# Monthly Specification Update

**Intel® Server Boards S2600WP Family**  
**Intel® Server Systems H2000WP Family**

*Intel Order Number G64830-007*

**September, 2013**

Figure 1. The Chassis Quick Reference with Incorrect Picture Titles

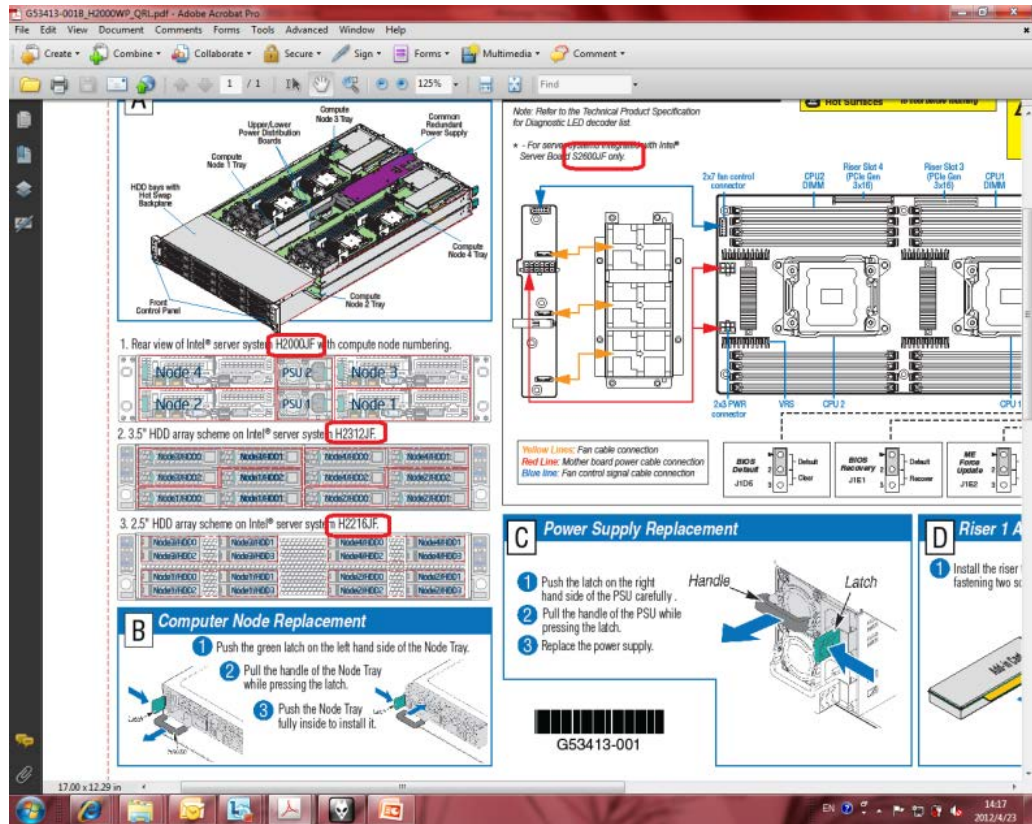
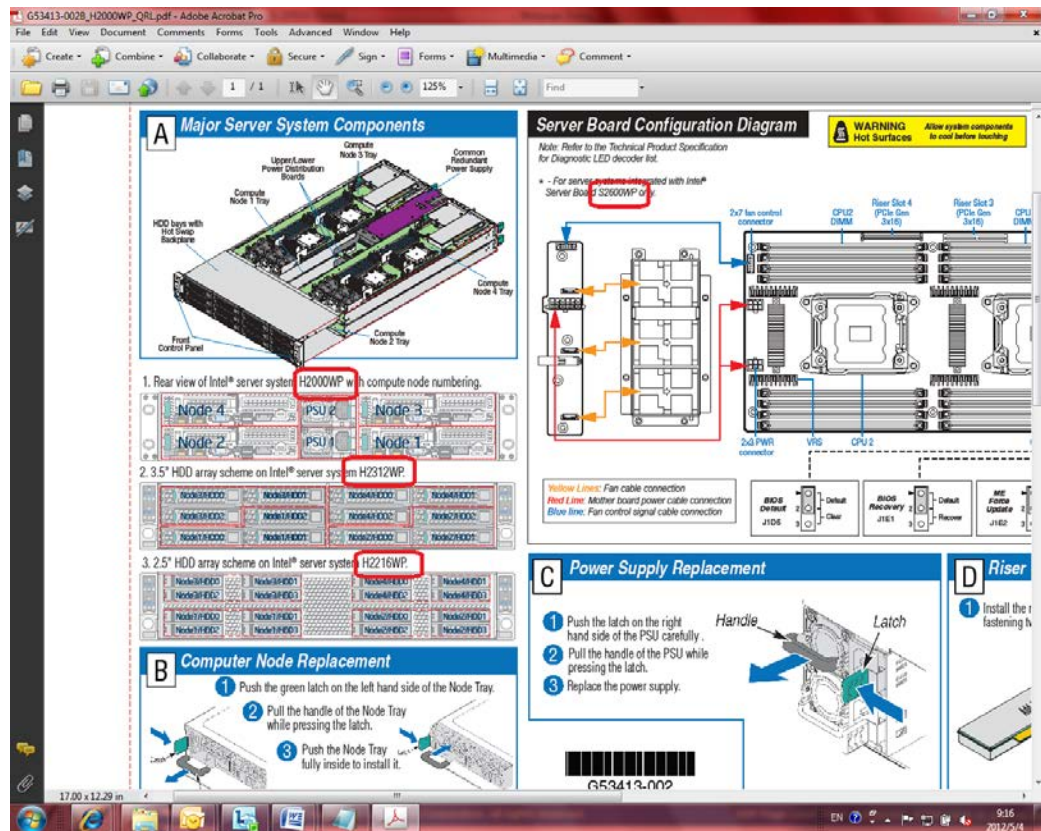
Problem The *Intel® Server System H2000WP Family Chassis Quick Reference* (document ID G53413-001) has four incorrect picture titles as shown below. The correct title names should be "H2000WP", "H2312WP", "H2216WP", and "S2600WP". All schemes and configuration diagrams are correct for H2000WP. The impacted servers systems are listed in the table below. This problem has been fixed in the updated Chassis Quick Reference (document ID G53413-002).

Status This issue is fixed with G53413-002.
